Braidwood Station, Units 1 and 2
Renewed Facility Operating License Nos. NPF-72 and NPF-77
NRC Docket Nos. STN-50-456 and STN-50-457

Subject: Response to Request for Additional Information for the License Amendment
Request to Utilize TVEL TVS-K Lead Test Assemblies

ATTACHMENT 3
Response to NRC Request for Additional Information [Non-Proprietary]

Figure 1-1: TVS-K LTA Project Relationships

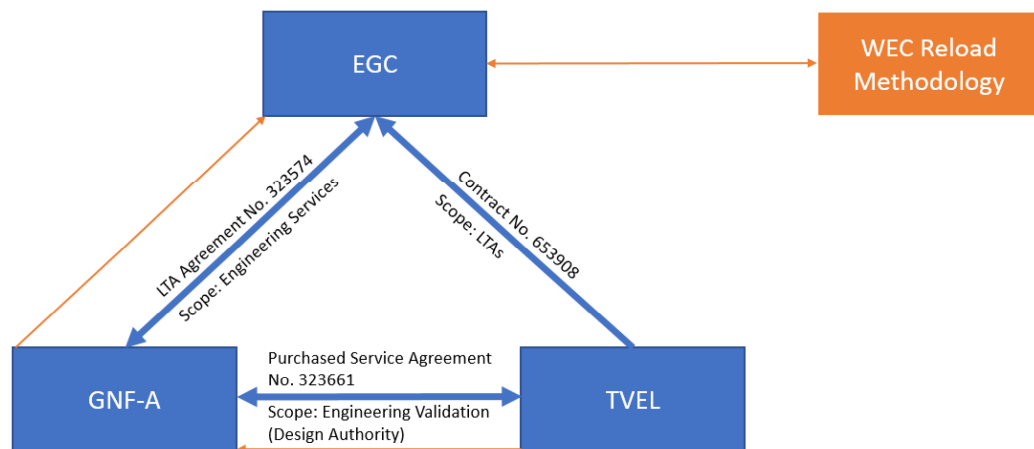
By letter, dated July 19, 2018 (ADAMS Accession No. ML18204A181), as supplemented by letter dated October 19, 2018 (ADAMS Accession No. ML18296A288), Exelon Generation Company, LLC, (Exelon) requested an amendment to add new License Conditions to Appendix C, "Additional Conditions," of the Braidwood Station Operating Licenses for Unit 1 and Unit 2, respectively, that would authorize the use of up to eight Joint Stock Company TVEL (TVEL) TVS-K lead test assemblies (LTAs) in non-limiting reactor core locations for operation and evaluation. Based on the staff's review of the submittal, the interface responsibility and relationships among the multiple organizations involved in this project (i.e. Exelon, Global Nuclear Fuels America, and TVEL) is not clear. Provide a description of the organizational structure, functional responsibilities, levels of authority and organizational interfaces that support the overall flow of quality assurance requirements for design, testing and fabrication of the TVS-K lead test assemblies. Also, provide a description of the procurement and fabrication processes with respect to compliance with the quality assurance requirements of Appendix B to 10 CFR Part 50 and the evaluation and reporting responsibilities of 10 CFR Part 21.

As described in the license amendment request submitted on July 19, 2018, the TVS-K Lead Test Assembly (LTA) project is a joint initiative among Exelon Generation Company, LLC (EGC), Joint Stock Company "TVEL", and Global Nuclear Fuels – Americas, LLC (GNF-A). The project is unusual compared to the previous Braidwood LTA project in that the engineering services vendor responsible for evaluation of the TVS-K LTAs (GNF-A), the fuel vendor (TVEL), and the licensing methodology vendor (Westinghouse Electric Company, LLC (WEC)) are separate entities. Figure 1-1 graphically depicts these relationships, which are described in more detail below.
